30-039-06918 RINCON UNIT #127

ENDURING RESOURCES, LLC

Re: Permanent Abandonment
Well: Rincon 127

CONDITIONS OF APPROVAL

BLM FLUID MINERALS Geologic Report

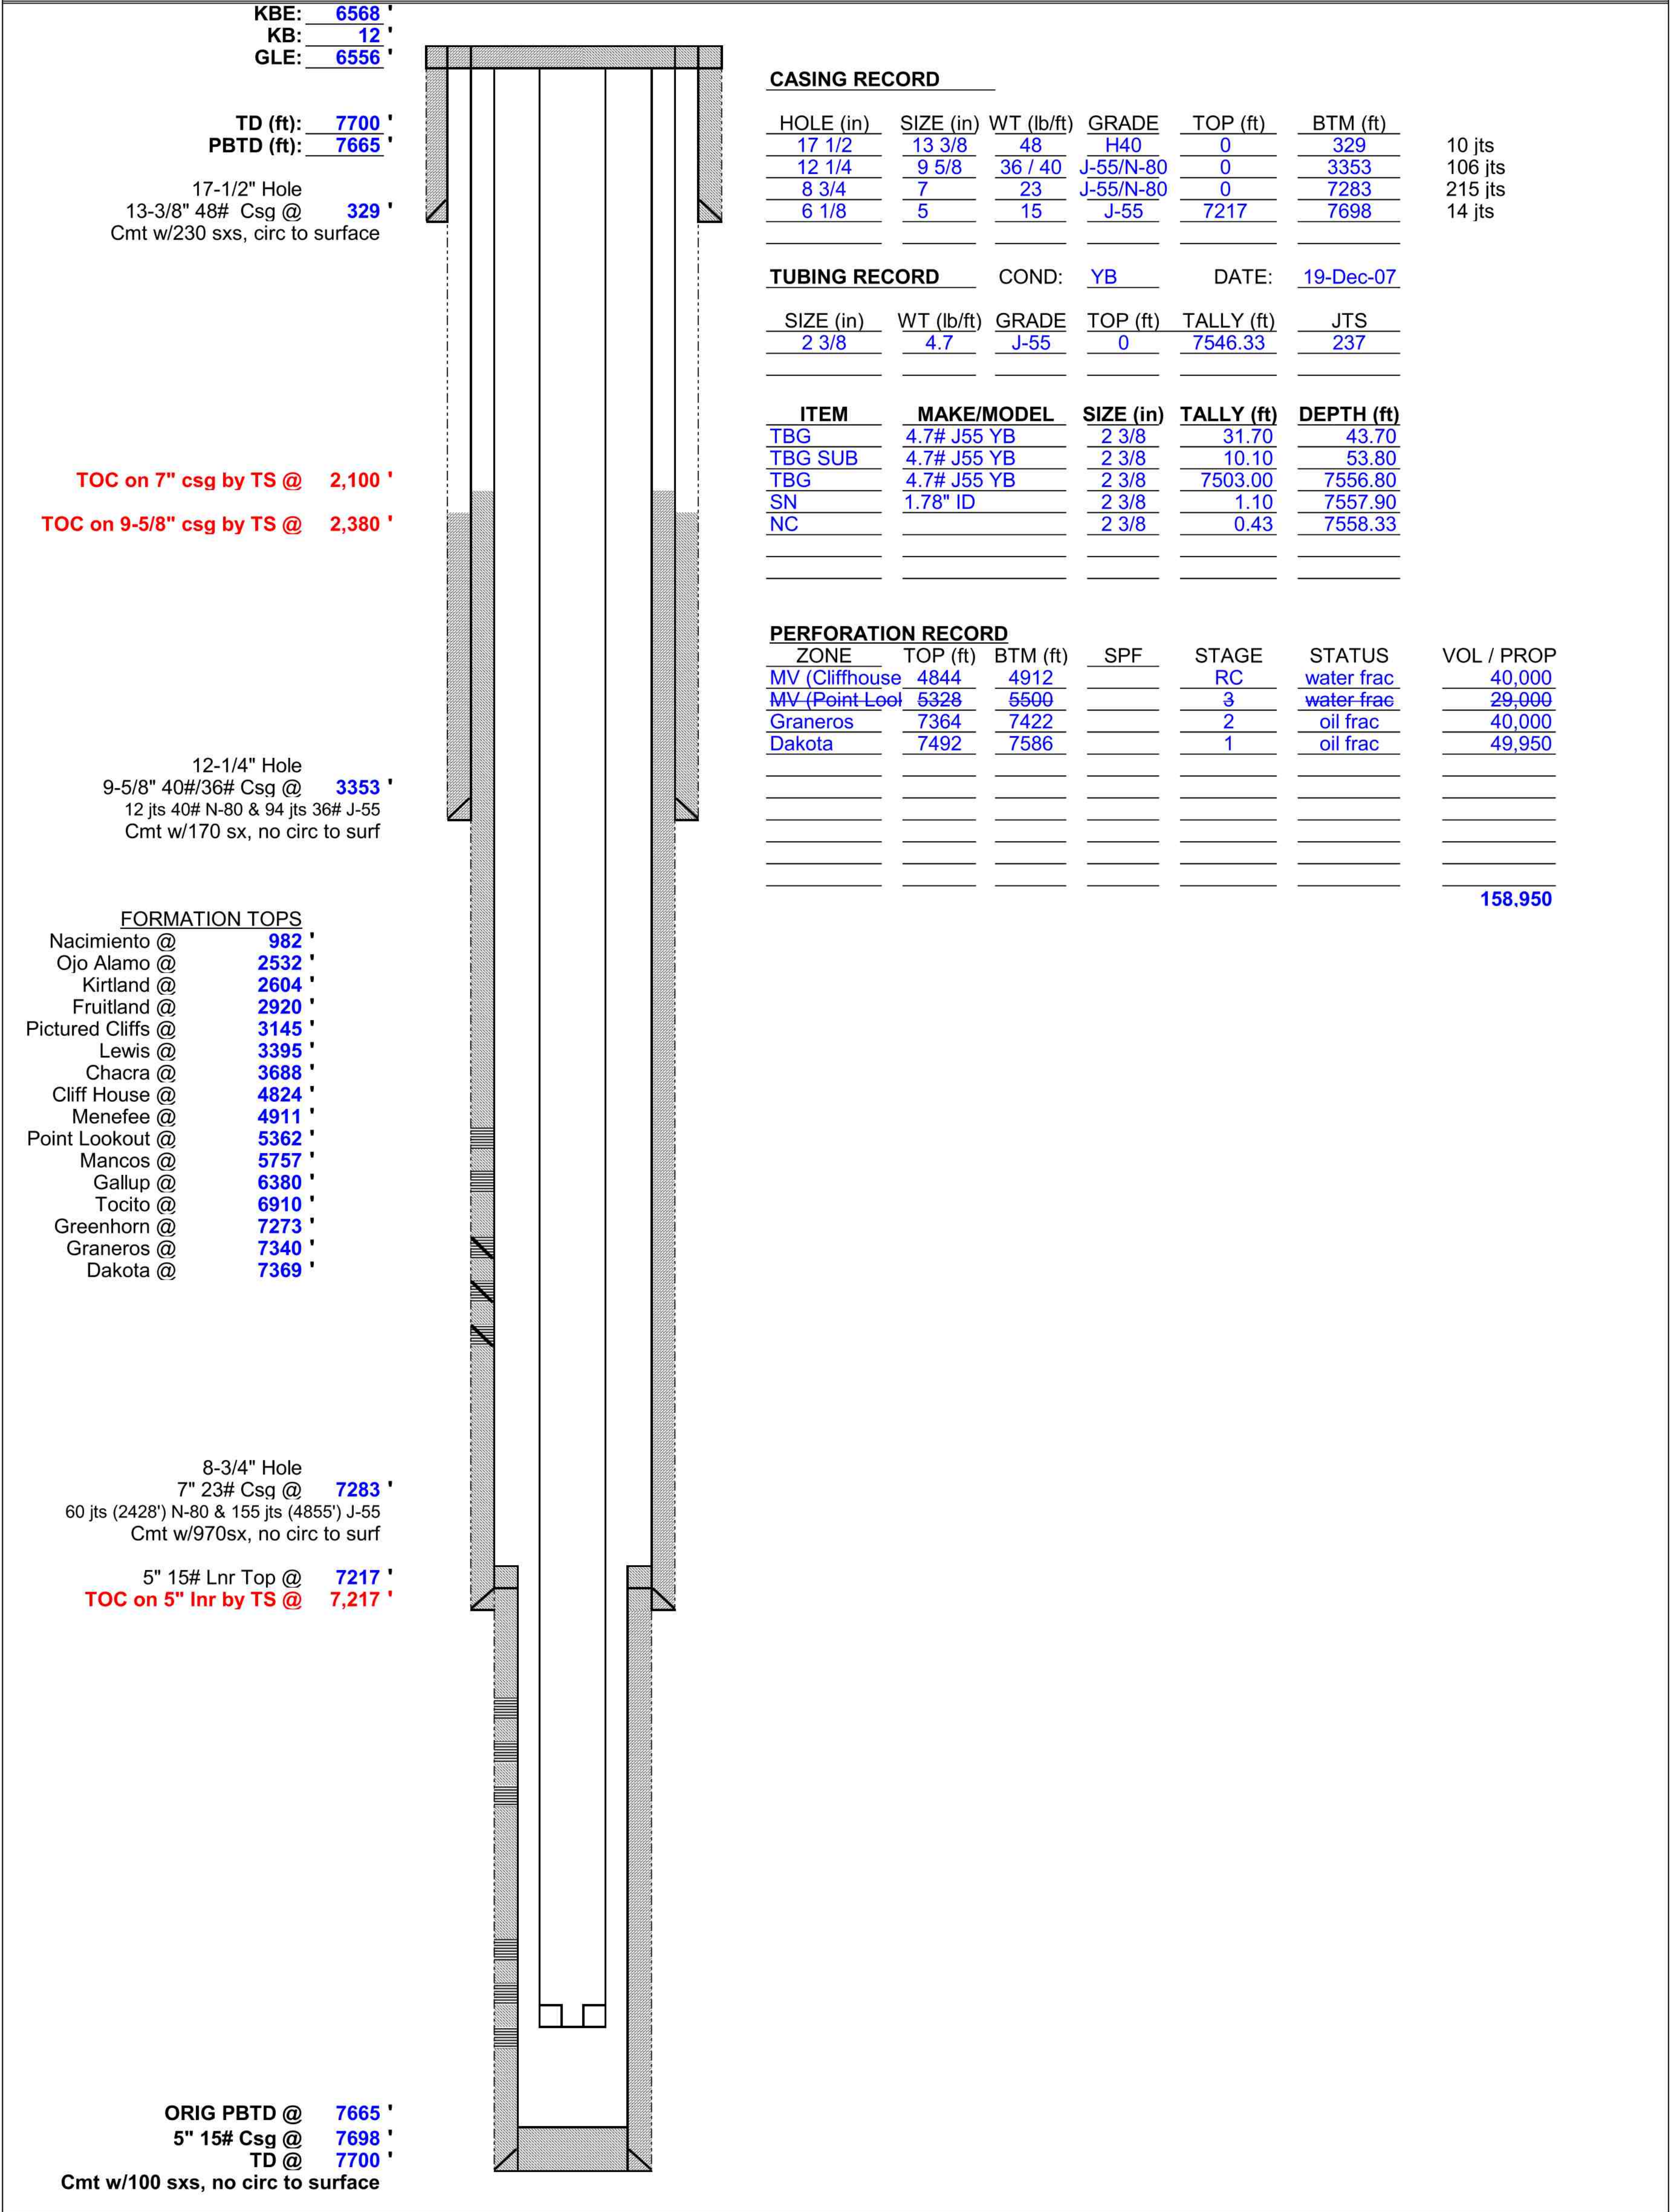
- Please ensure that the top of the Fruitland formation as well as the entire Ojo Alamo aquifer, identified in this report, are isolated by proper placement of cement plugs. This will protect the freshwater sands in this well bore.

Please note that the beds identified as Gallup are not the main Gallup but rather probable discontinuous Ss lenses at a similar or higher stratigraphic level within the Mancos..

Please note that the BLM geologist's picks for several formation tops vary slightly to significantly from the operator's picks. These include the Nacimiento, Ojo Alamo, Chacra, Mancos Shale, Gallup, and the Tocito Ss lentil.

4. BLM picks top of Gallup at 6560. Ensure coverage of Gallup top 6510-6610
5. BLM picks top of Ojo Alamo at 2300. Ensure coverage of Ojo Alamo top 2200-2400

6. BLM picks top of Nacimiento at 1260. Ensure coverage of Ojo Alamo top 1210-1310
7. Submit a copy of the updated procedure reflecting all COAs to the following email addresses before operations commence: jkillins@blm.gov , jhoffman@blm.gov and Brandon.Powell@state.nm.us
